Reference: Sailplane model  
H 301 and H 301 Libelle, German Data Sheet No. 251,  
from Serial No. 2 and on, however, Serial  
No. 2 to 85 only, if the elevator actuator  
bracket has welded assembly guides instead of  
screwed guides.  
Standard Libelle and  
Standard Libelle 201 B, German Data Sheet No. 251,  
all Serial Numbers,  
Club Libelle 205, German Data Sheet Nr. 304, up to  
Serial Number 107,  
Hornet, up to Serial Number 3

Subject: Reinforcement of the elevator assembly guides.

TECHNISCHE MITTEILUNG  
TECHNICAL NOTE

201-20  
Nr: 205-6, 206-1  
301-30

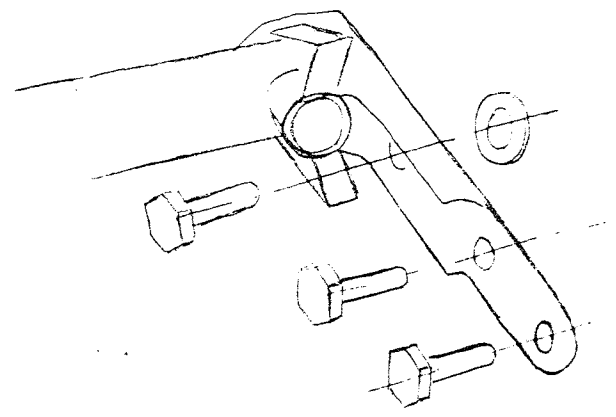
Method: 1. With a 5 x powered magnifier visually inspect  
the assembly guides for distortion, bending  
and/or for cracks in the welded seam.  
2. If damage is found replace the bracket  
immediately with a bracket to be reinforced  
according to method 4.  
3. If no damage is found replace the bracket with  
a bracket to be reinforced according to  
method 4 before the date quoted in "Urgency".  
4. Weld in two sheet metal strips according to the  
following drawings to reinforce both guides.  
(see next page)

Sheet metal to specification 1.7214.4 or 1.7734.4, welding material to specification 1.7734.2 or 1.7324.0, welding process WIG (Wolfram-Inert-Gas). After removing the bracket insert a pin 10 mm  $\phi$  into the tube instead of the actuator pin to prevent warping during welding. It should be possible to insert this pin simply by hand. Remove the pin after the bracket has cooled down. Preserve the bracket again (recommended single component primer B 1742 from Lackfabrik Bäder and nitro lacquer). Fit the bracket to the tailplane and pay attention to the 2 washers between bracket and ball bearings.
